Technical Note

Project No: ITB14224
Project Title: Nursery Fields
Title: ITB14224-015
Ref: LHA and PROW Response
Date: 25 February 2021

- 1.1 Landform Bersted Ltd (Landform) has submitted a planning application to Arun District Council (ADC) for 225 new homes on land to the north of Chalcraft Lane known as Nursery Fields (planning ref: BE/148/20).

Image 3.1: PROW Connectivity Plan Extract

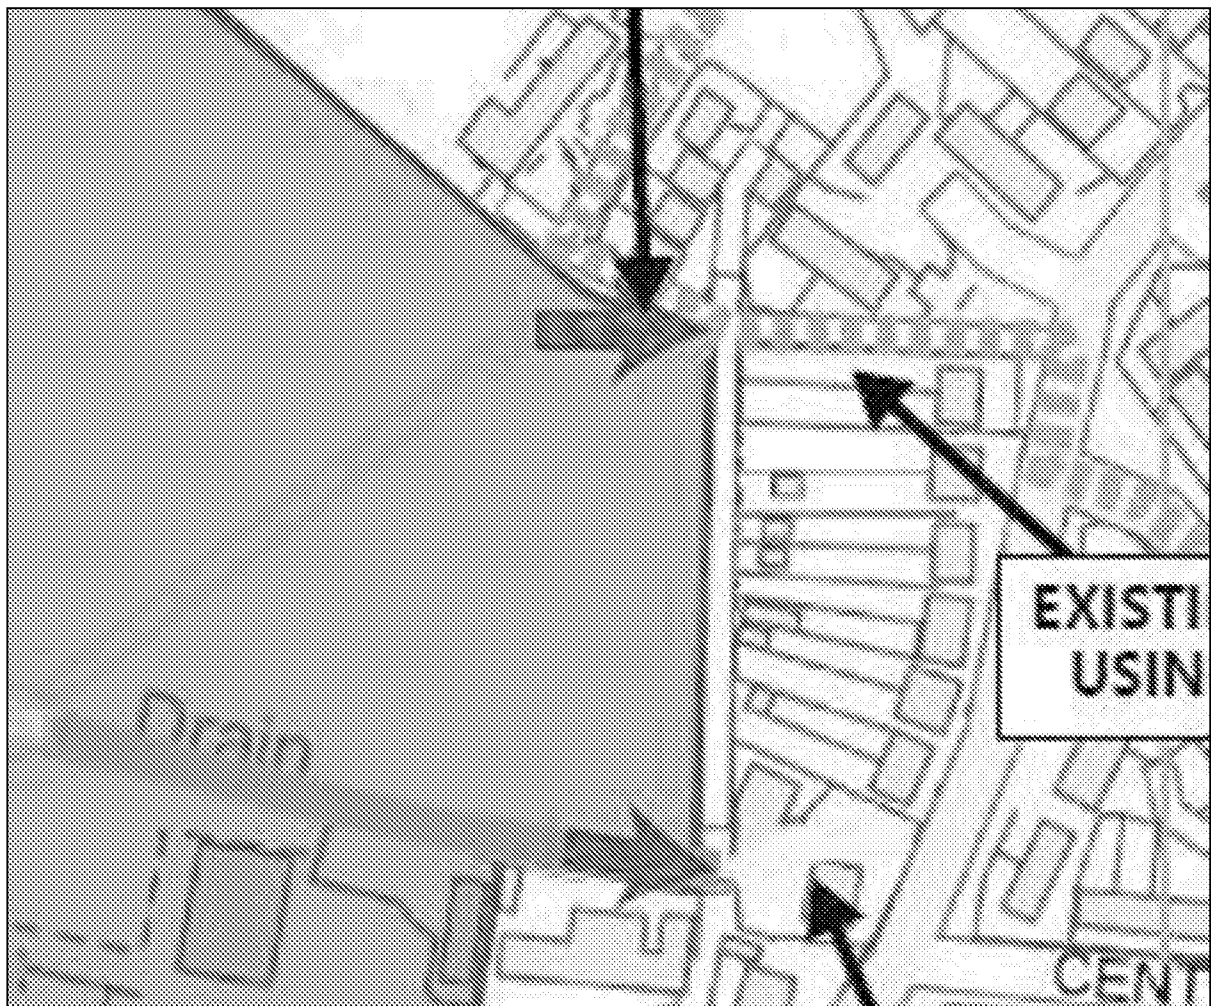
24. Given that the site is indicating pedestrian/cyclist accesses at two other points (namely via footpath 136 (notwithstanding the potential issues identified with this) and onto the community centre access road (which connects to an existing Toucan crossing linking to Central Drive), the provision for cyclists alongside the main access road and the associated works on Chalcraft Lane are potentially superfluous and as shown conflict with LTN 1/20.

25. It's recommended that this aspect (namely the provision of shared use facility within the development, the Toucan crossing, and the proposed widening works along Chalcraft Lane) of the application is either removed or reassessed and amended to ensure compliance with LTN 1/20. In the event this southern route is removed, the Green Infrastructure Parameter Plan would need to be updated.

26. Through the design of the on-site layout, the use of the other two pedestrian/cyclist access points should be further promoted. This would necessitate changes to the Green Infrastructure Parameter Plan. The Parameter Plan currently shows a very indirect connection through the site onto the existing cycle route on the community centre access road. A far more direct and convenient route could be achieved.

- 3.3.1 WSCC Highways have indicated that the cycle connection through the site on to the community centre access road is indirect, and that a more direct connection can be made achieved.
- 3.3.2 To address this, the PROW Connectivity Plan and Parameter Plan have been updated. Single points have been identified on the Parameter Plan (identified as A and B) and the form of the connection between the 2 points would be a matter to be agreed as part of a future Reserved Matters Application relating to layout. The PROW Connectivity Plan identifies an indicative direct connection.

- 3.3.3 Signage will be introduced to direct cyclists north, and the remainder of FP 136 to the site boundary will be improved for use by pedestrians only. A financial contribution will be made to enable WSCC PROW to resurface the remaining section of FP136 outside of the site boundary.

DRAWING No: ITB14224-GA-009	REV: B
-----------------------------	--------

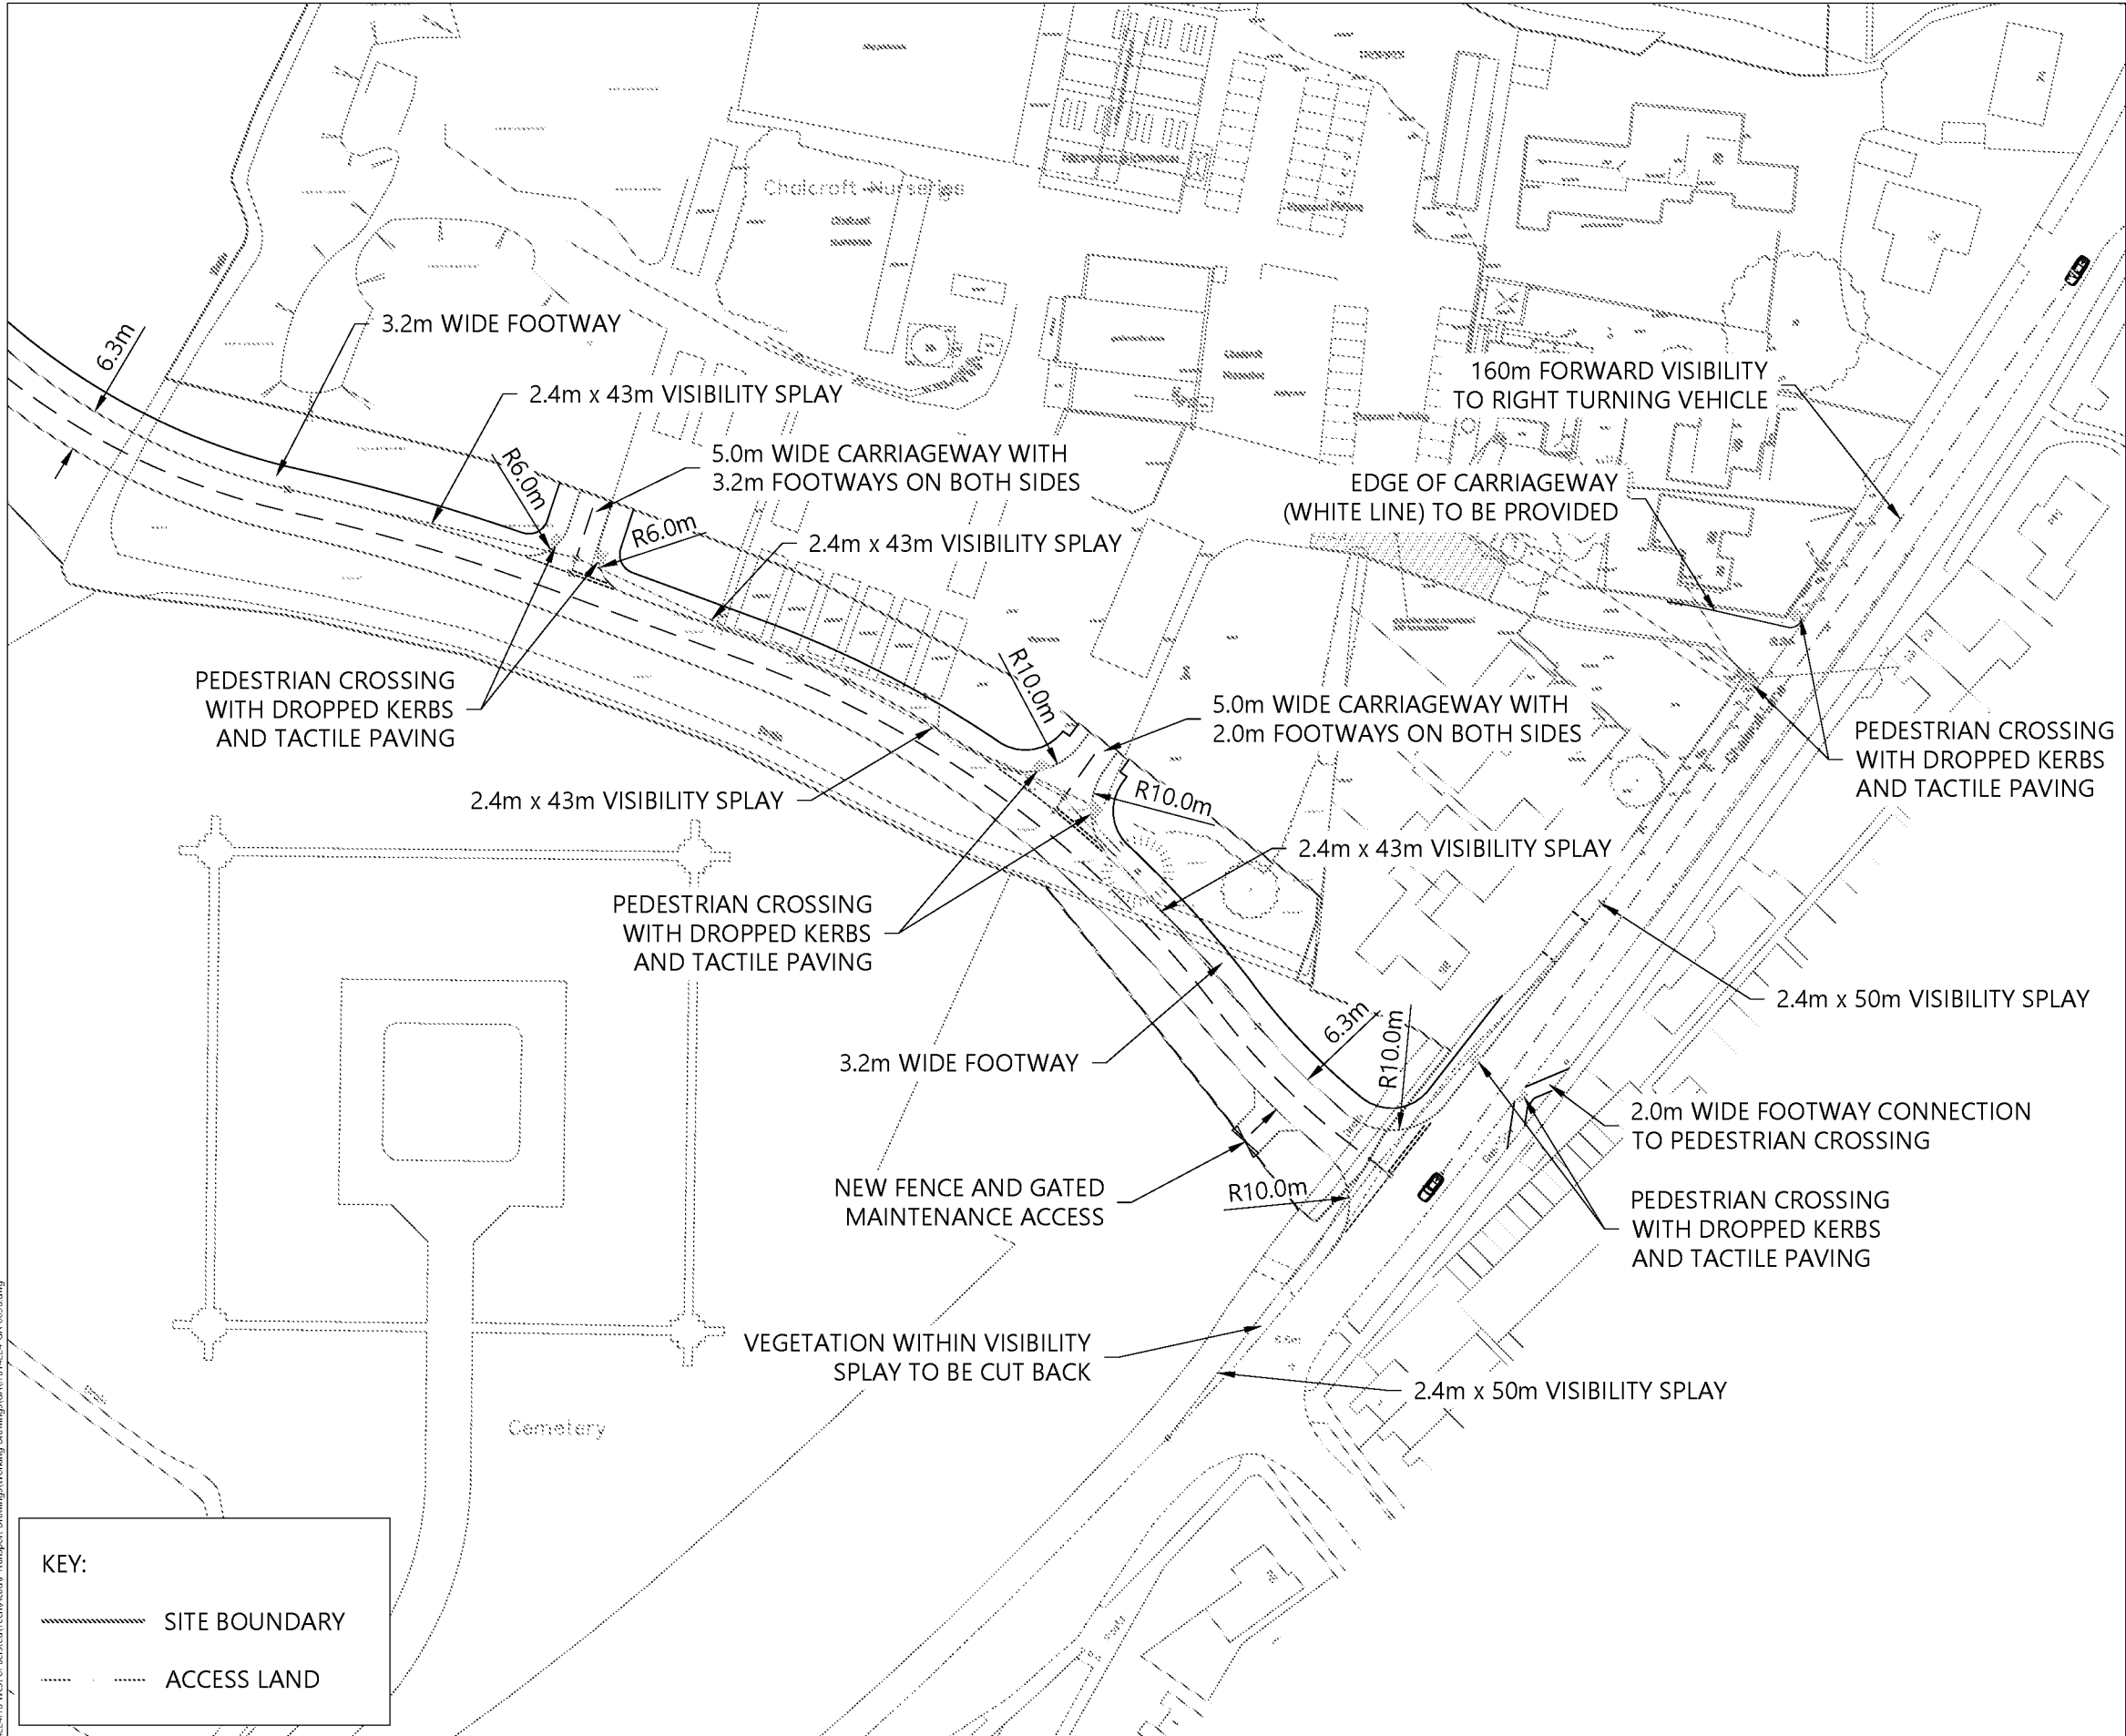
8. Related to the above point, although the vehicular access remains effectively unchanged, the access drawing now includes a Toucan controlled crossing to the immediate north. Further comments are made on the Toucan crossing and related infrastructure within the 'Access by Sustainable Modes' section.

23. In respects of the current application, a shared foot/cycle way is indicated on the north side of the access road serving the development (it's acknowledged that details of the access road are not to be approved at this stage although such matters are shown on the Green Infrastructure Parameter Plan that is to be approved) linking into a Toucan crossing on Chalcraft Lane. The existing footway on the eastern side of Chalcraft Lane is indicated to be widened to 3.2 metres from the Toucan crossing to Central Drive, from where cyclists will join the carriageway. There is very limited consideration within the TA in terms of how this proposed arrangement complies with current guidance. LTN 1/20 in particular advises against shared use foot/cycle ways and instead promotes the physical segregation of cyclists and pedestrians.

- 2.4.1 WSCC has requested that the cycle infrastructure adjacent to the site access road and the associated infrastructure along Chalcraft Lane (including a Toucan crossing) is removed, focussing cycle access

towards the community centre access road and existing cycle infrastructure along this corridor towards Bognor Regis.

- 2.4.2 The site access drawing has been amended to reflect these amendments and the revised arrangements are presented as **Drawing ITB14224-GA-009 Rev B**. Similarly, the Land Use Parameter Plan and the Green Infrastructure Plan have also been updated and copies of these are provided at **Appendix C**.
